T.I. No.: 2020 - 15 Updated: -	Topic: Grinder V3.0
---	----------------------------

NEW GENERATION OF GRINDER V3.0

INTRODUCTION INTO THE SERIES FROM CALENDAR WEEK 19/2020

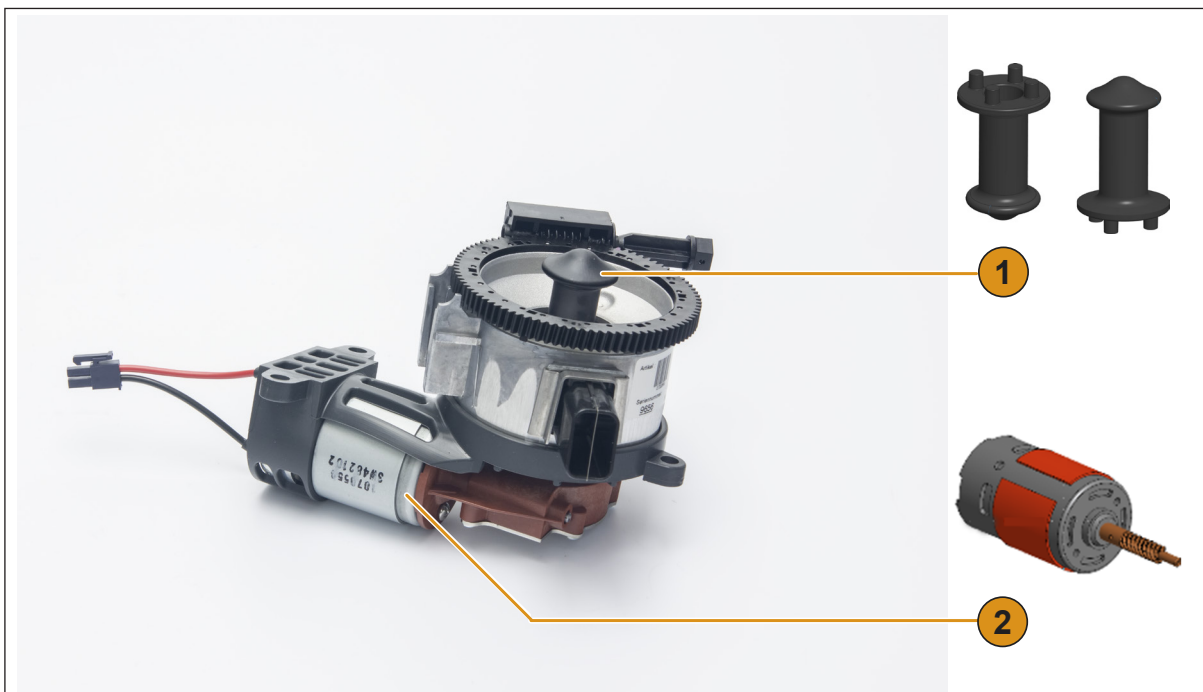
- 1** Finger protection (072260) without threaded profile
- 2** Motor (073650) with shafting

- After long-term test, involving multiple grinders and variety of coffee beans, it was established that we can achieve a more consistent dispensing behaviour when a finger protection without threading is applied.
- The trade-off is a slightly lower output in gram per second, which depends on the grind level setting. A performance reduction towards the range of the V1.0 grinder is expected.
